AGENDA PACKET

FEBUARY 28, 2023 MEETING Part 2B of 3

TO:	Chairperson Janet Andersen and Members of Lewisboro Planning Board
CC:	Ciorsdan Conran Judson Siebert, Esq. Kevin Kelly, Building Inspector
FROM:	Jan K. Johannessen, AICP Joseph M. Cermele, P.E., CFM Town Consulting Professionals
DATE:	February 24, 2023
RE:	Wetland Permit & Stormwater Permit Susan Morrissey 10 Hoyt Street Sheet 036C, Block 11172, Lot 005

Re: 10 Hoyt Street Sheet 036C, Block 11172, Lot 005 Application for Wetland Activity Permit and Stormwater Management Permit

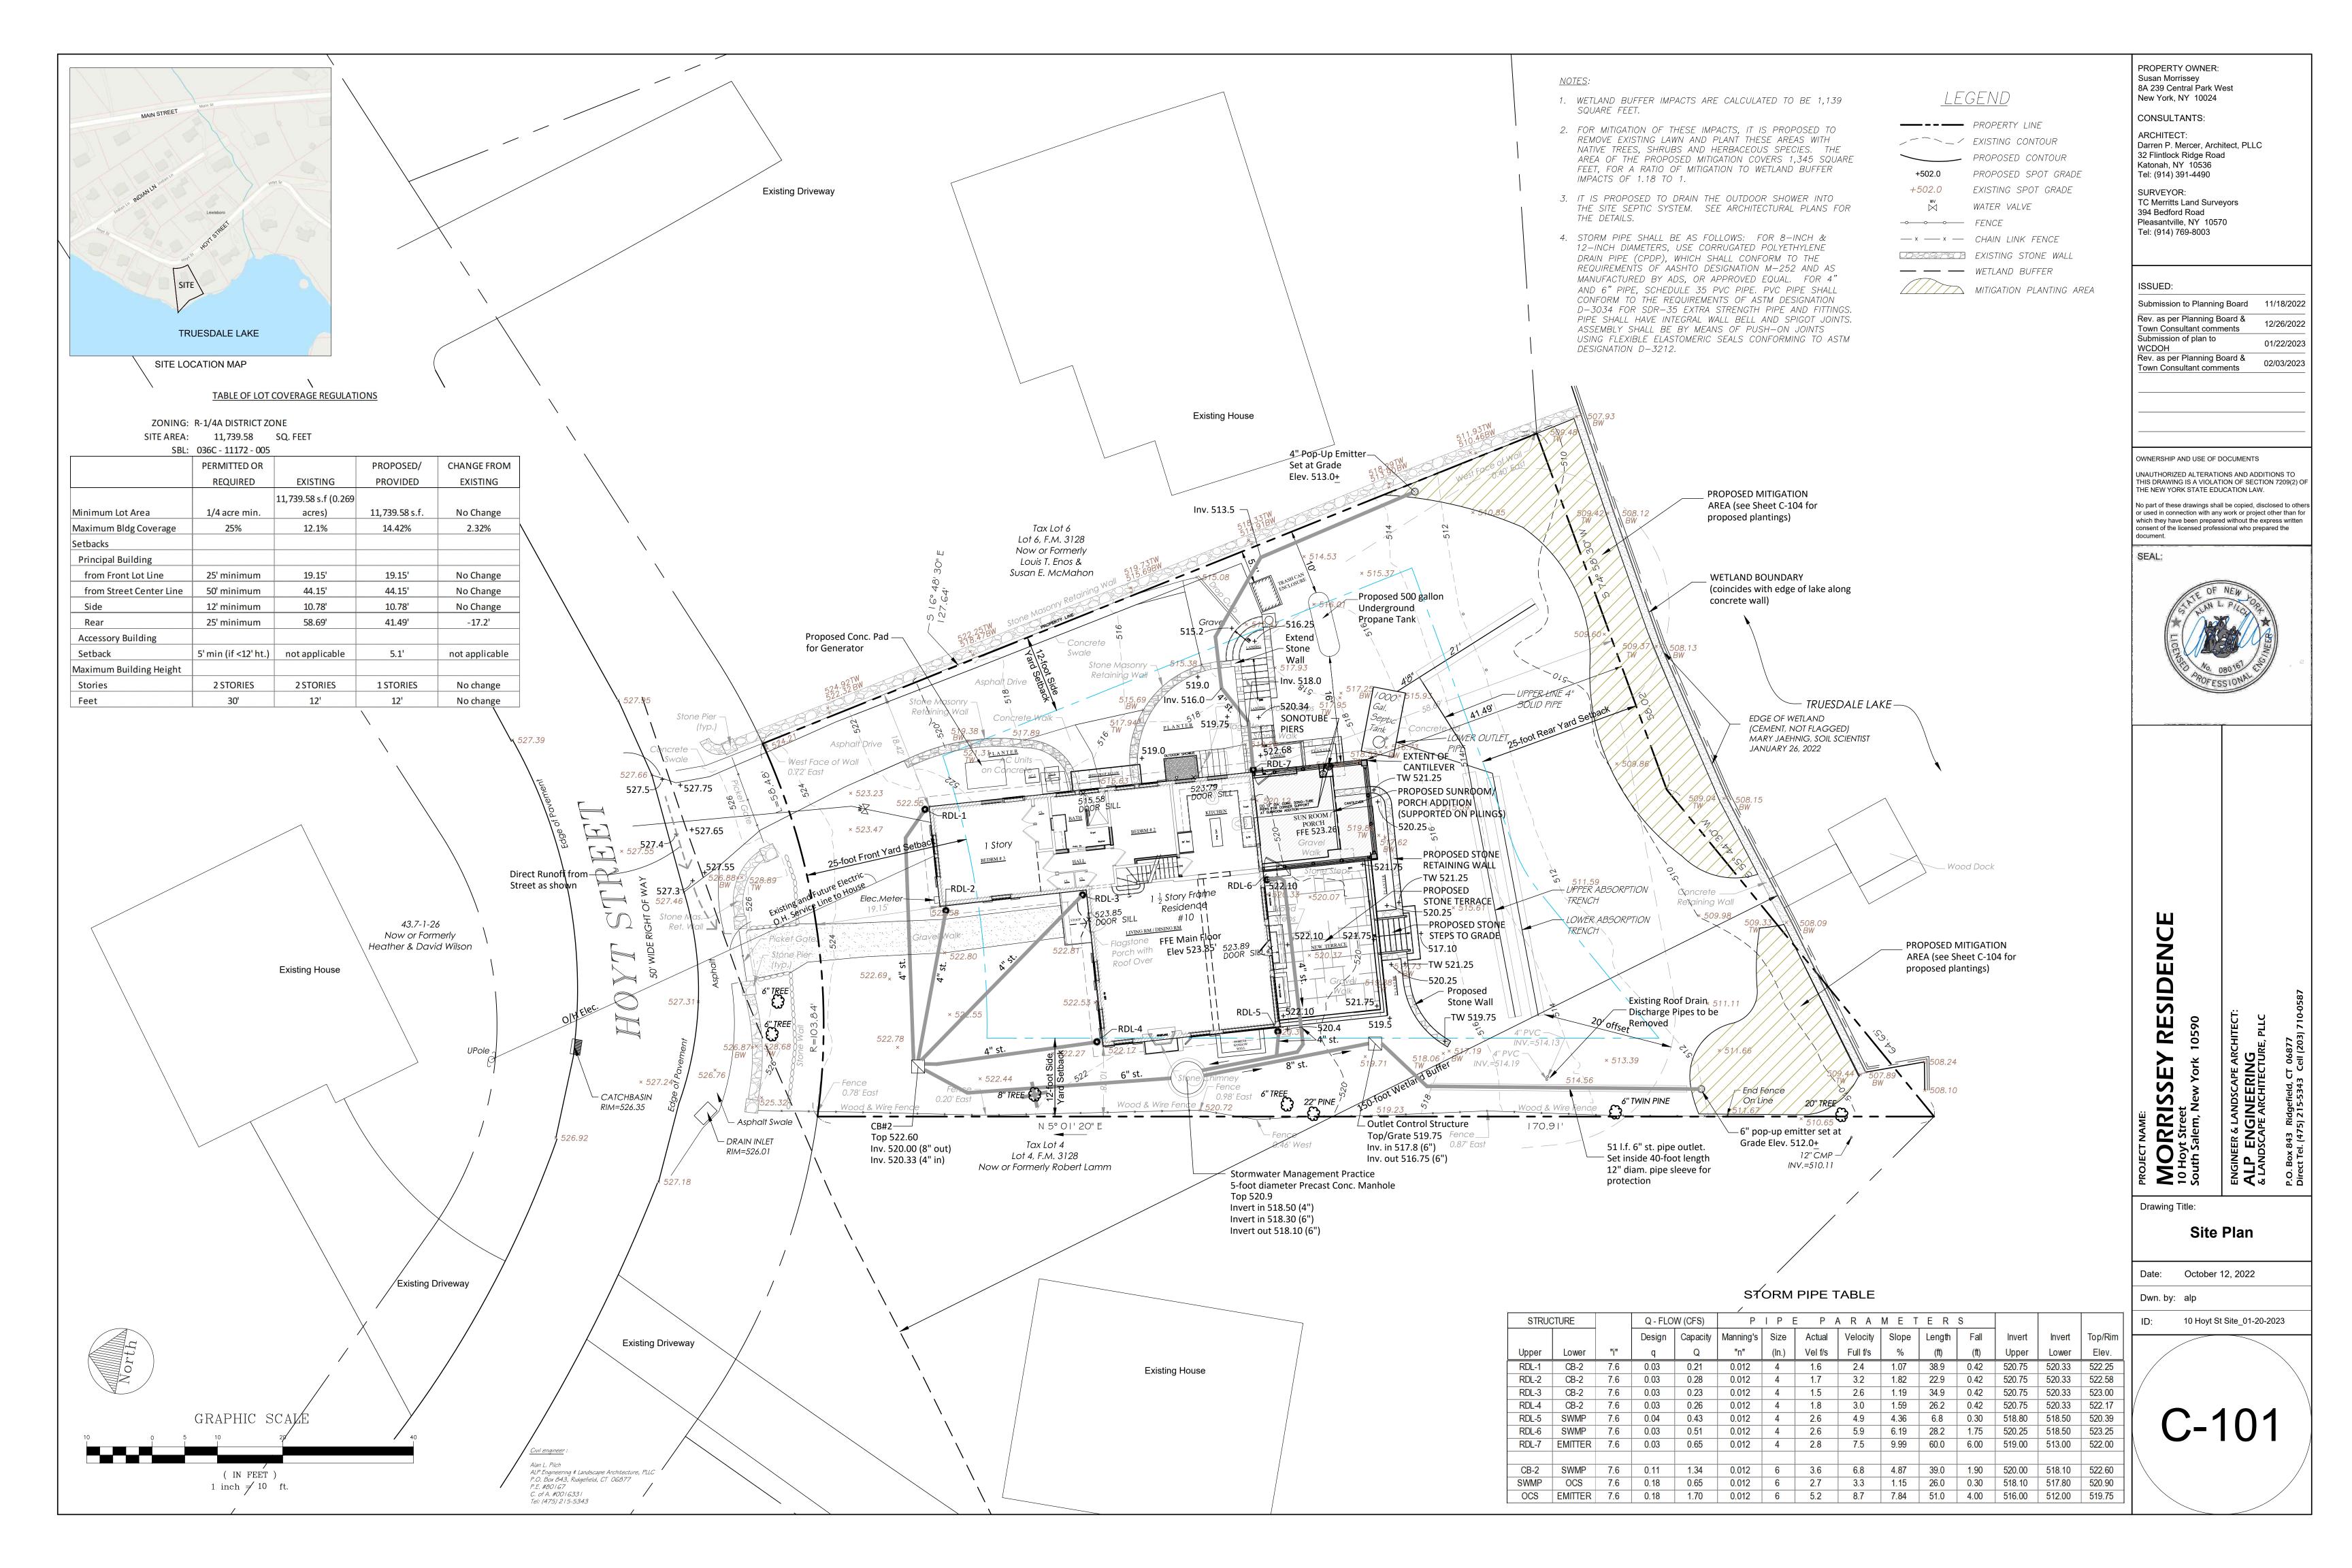
9. As previously requested, the plan shall note the proposed building floor elevation, patio elevation and illustrate proposed contours and spot elevations as needed.

<u>Response</u>: The building finished floor elevation has been added to the plan (see Sheet C-101). The grade of the proposed patio has also been added with spot elevations shown.

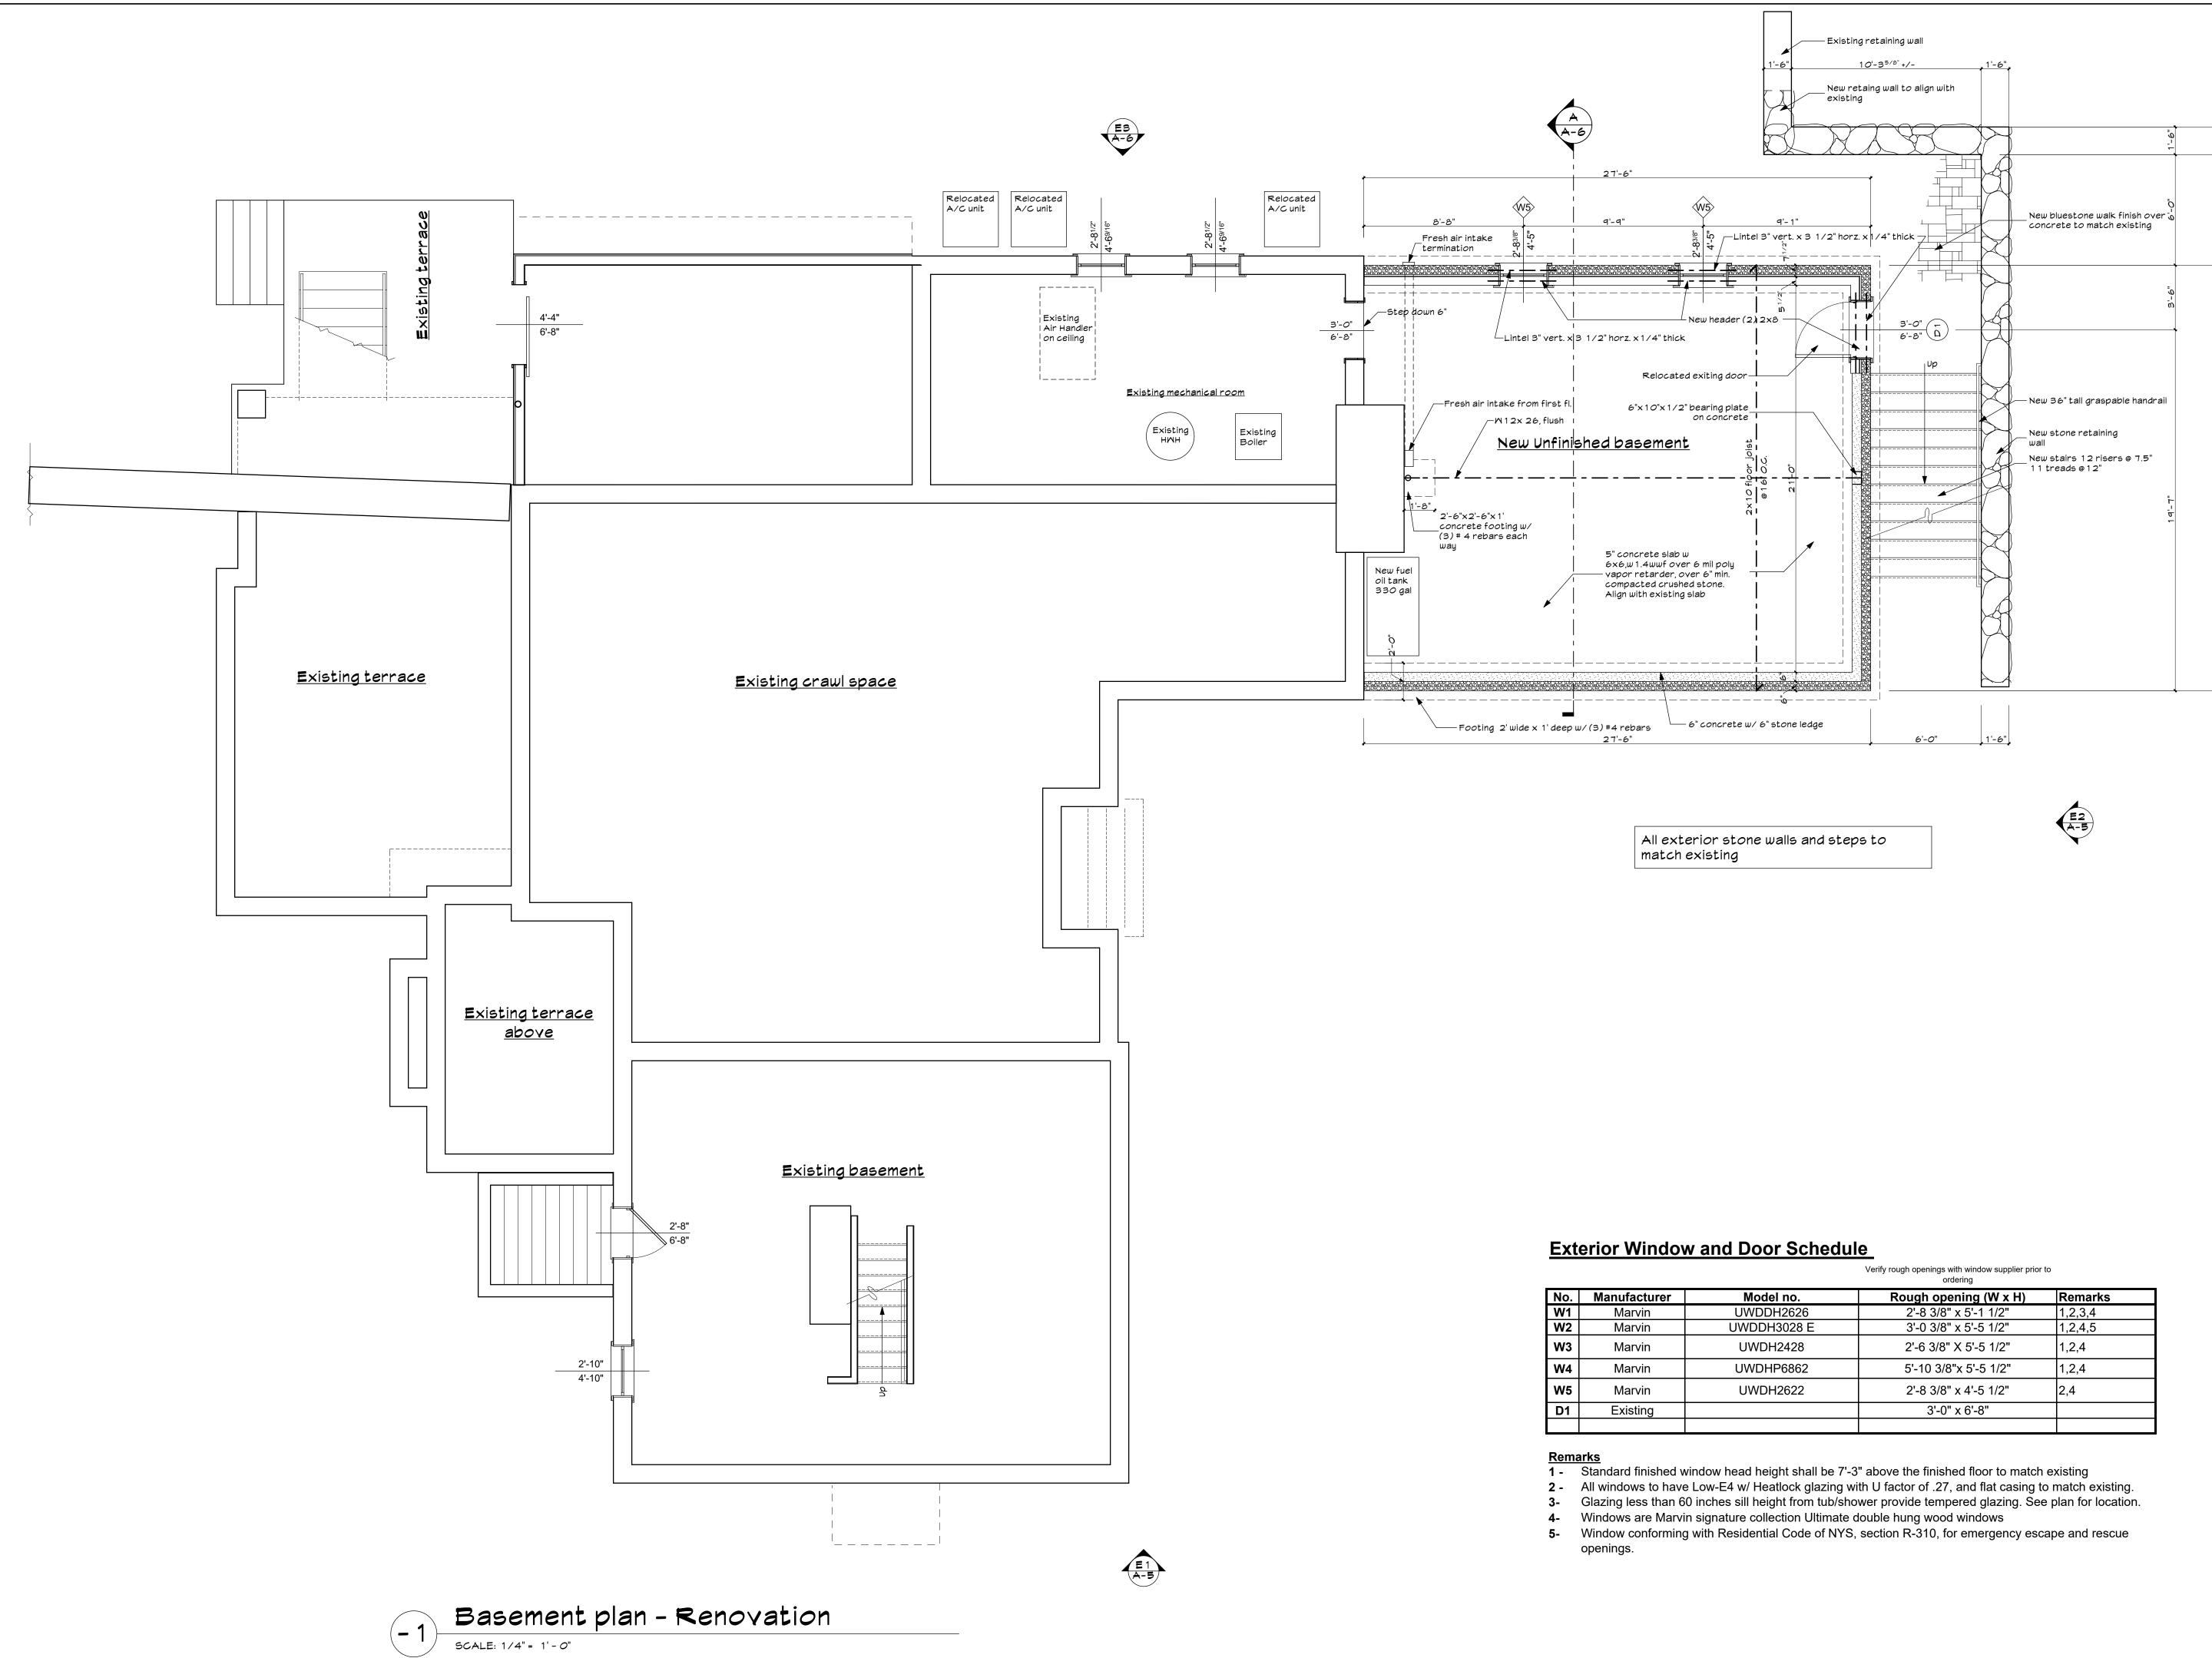
- 2. The area of the addition on Sheet A-1, and associated narratives, does not match the calculations for the proposed building coverage of Sheet A-2. Please coordinate as needed.
